The Commission has issued the enclosed Amendment Nos. 57 and 56 to Facility Operating License Nos. DPR-32 and DPR-37 for the Surry Power Station, Unit Nos. 1 and 2. The amendments consist of changes to the Technical Specifications in response to your application transmitted by letter dated December 15, 1978.

The amendments revise the Technical Specifications to specify new pressure-temperature limits for heatup and cooldown operations.

ATTACHMENT TO LICENSE AMENDMENT NOS. 57 AND 56
FACILITY OPERATING LICENSE NOS. DPR-32 AND DPR-37
DOCKET NOS. 50-280 AND 50-281

SAFETY EVALUATION BY THE OFFICE OF NUCLEAR REACTOR REGULATION

TS FIG 3.1-1

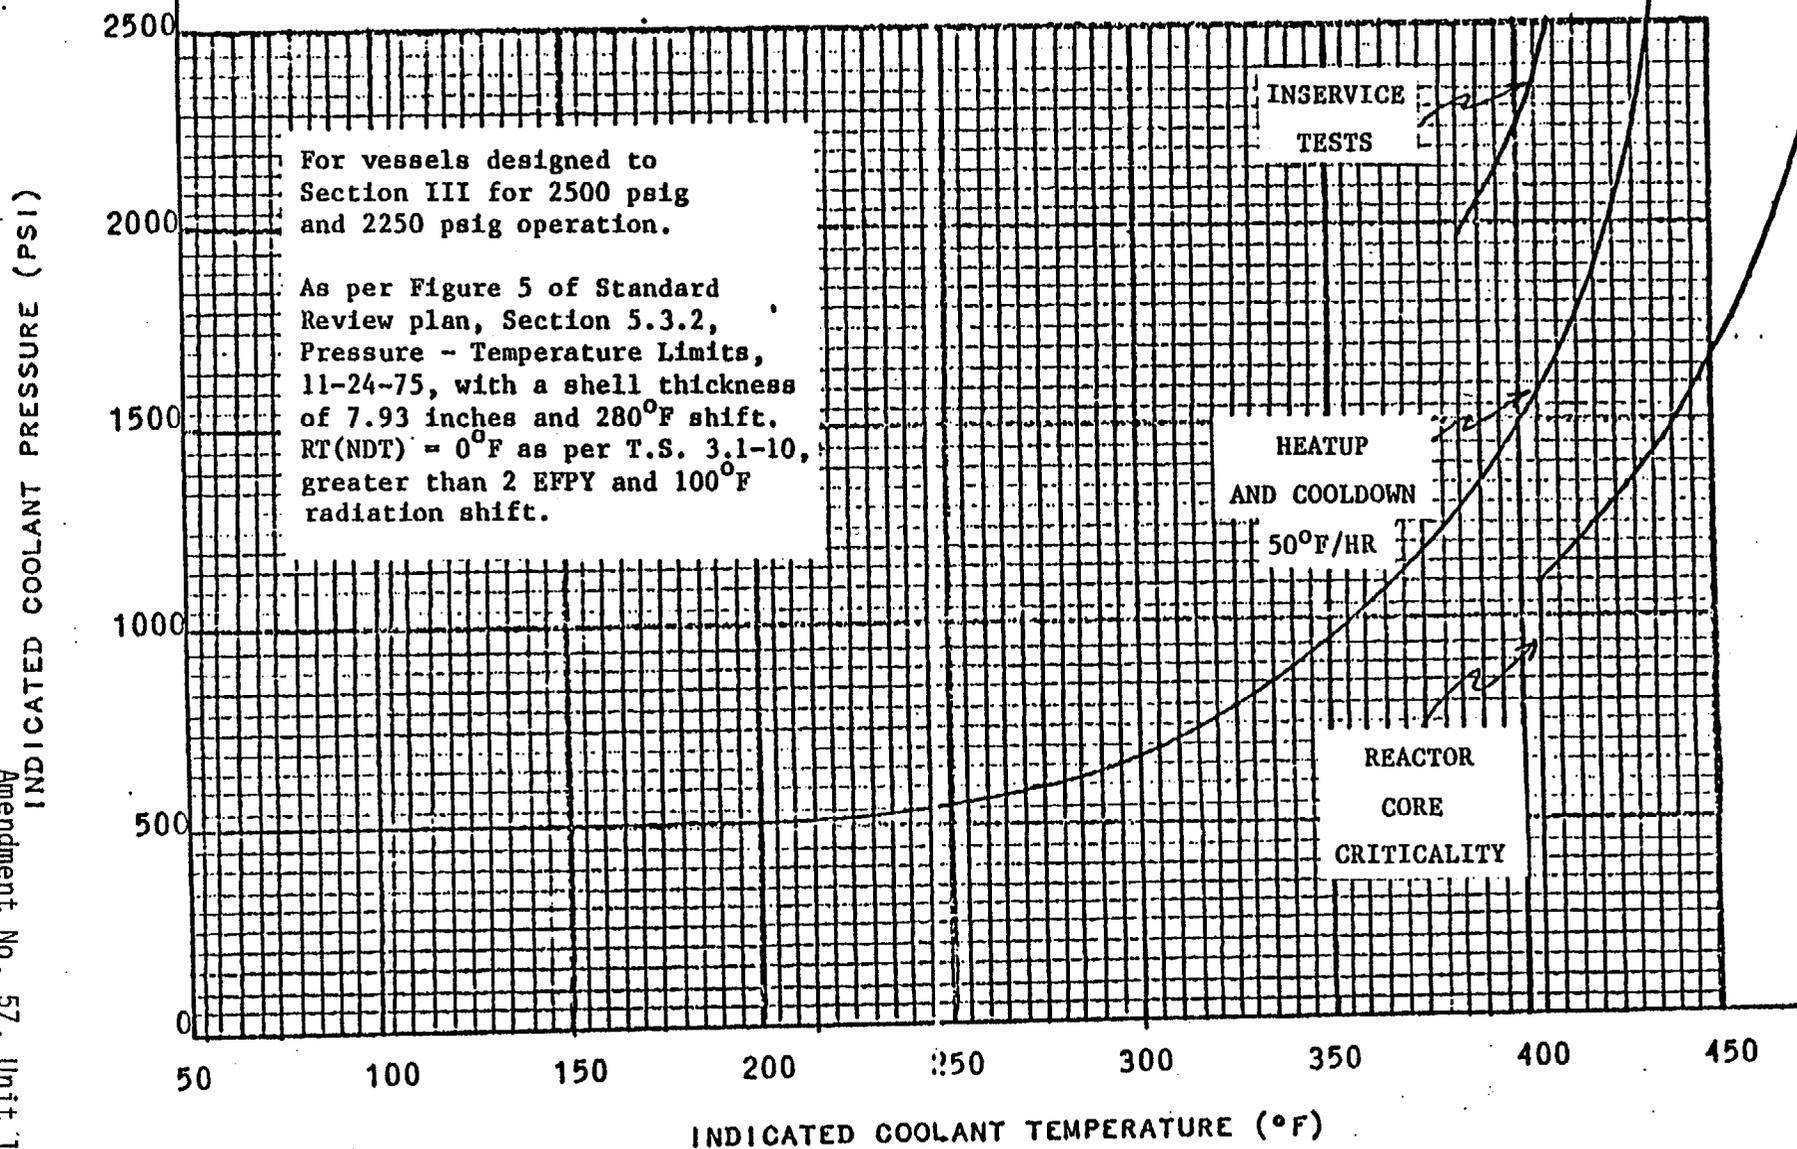
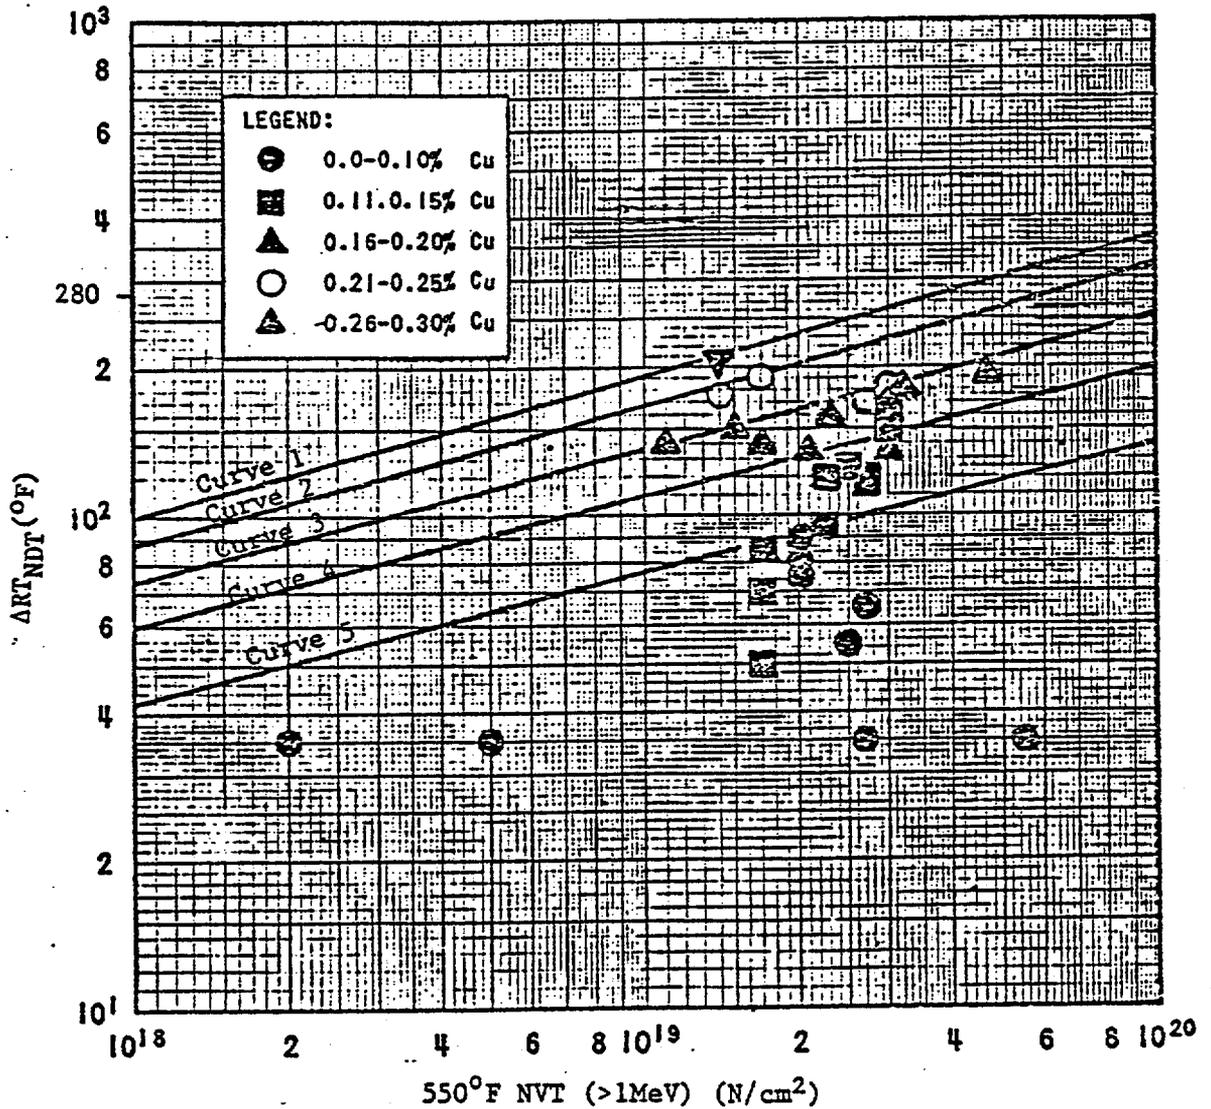
By letter dated December 15, 1978, Virginia Electric and Power Company (VEPCO) submitted an application to amend the Technical Specifications appended to Facility Operating Licenses DPR-32 and DPR-37 for Surry Units 1 and 2. The requested change would extend the acceptable operating period of the present operating limits from 3.8 EFPY to 11 EFPY.

The operating limits currently in the Technical Specifications are acceptable for operation to 3.8 EFPY. The same pressure-temperature operating limits are used for both Surry reactor vessels. The limits are based on the weld metal in the Surry 1 vessel which is the most limiting material. To date one material surveillance capsule has been removed from each vessel and tested. The test results on these capsules clearly show that the Unit 1 surveillance weld metal is the limiting material. However, this weld material is not identical to the weld metal used to fabricate the reactor vessel; i.e., these welds were not made from the same heats of weld wire and flux. Therefore, VEPCO recalculated the amount of radiation damage using damage prediction curves supplied by Westinghouse. This calculation showed that the present limit curves are acceptable through 32 EFPY.

The results of the tests on the two surveillance capsules were reviewed again. It is concluded that the limiting material is the Unit 1 weld metal. At a fluence of 2.5×10^{18} n/cm² this weld metal shows an increase in RT_{NDT} of 165°F. This increase in RT_{NDT} is approximately on the upper limit line of Regulatory Guide 1.99, Revision 1 and is consistent with data generated from other surveillance programs on similar weld metal samples. Using the above shift in RT_{NDT} and the procedures in Regulatory Guide 1.99, Revision 1, the staff finds that the operating limits currently in the Technical Specifications are acceptable for operation through 11 EFPY. We have discussed this with the licensee and he agrees with this change. These operating limits are acceptable for both Surry 1 and 2 since the limiting material in the Surry 2 reactor vessel has a greater resistance to radiation damage than the limiting material in the Unit 1 vessel. For this operating period these operating limits are in accordance with Appendix G, 10 CFR 50. Conformance with Appendix G to 10 CFR Part 50 in establishing safe operating limitations will ensure adequate safety margins during operation, testing,

FIGURE VALID UP TO 11 EFPY.

Figure 3.1-2. Radiation Induced Increase In Transition Temperature

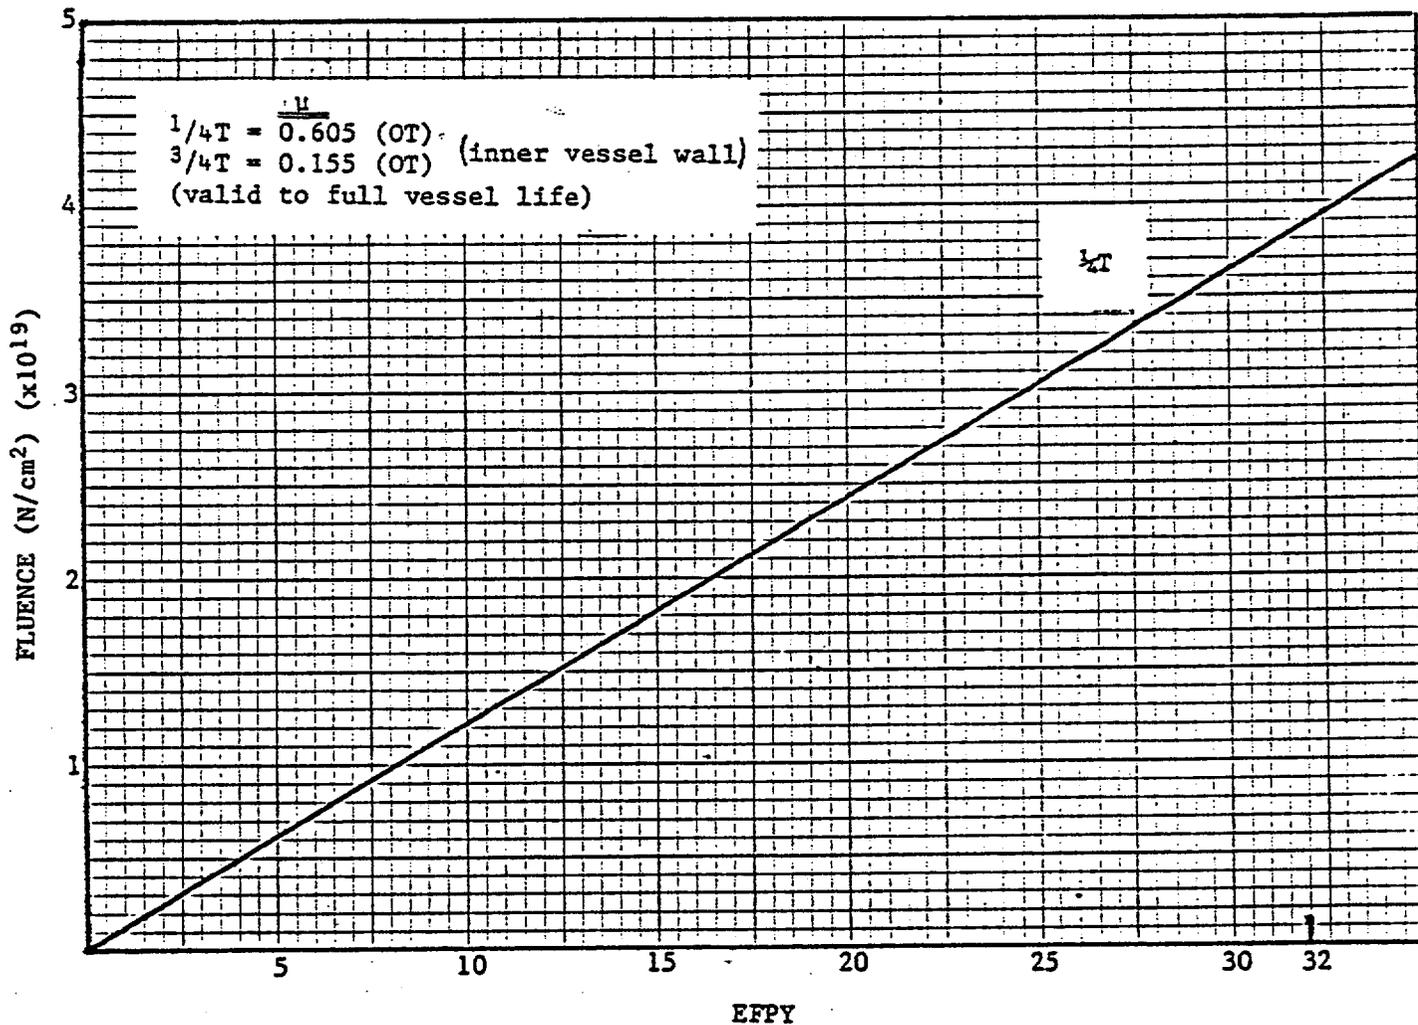
NOTE: Slope of line (ϕ) above was determined from T.S. Figure 3.1-2 with a 0.25% Cu weld for 32 EFPY's and a 2800°F shift as determined for T.S. Figure 3.1-1. It was calculated as follows:

$$\phi = \frac{3.85 \times 10^{19} \text{N/cm}^2}{32 \text{ EFPY}} = 1.203 \times 10^{18} \text{N}/(\text{cm}^2\text{-EFPY})$$

Figure valid up to 11 EFPY
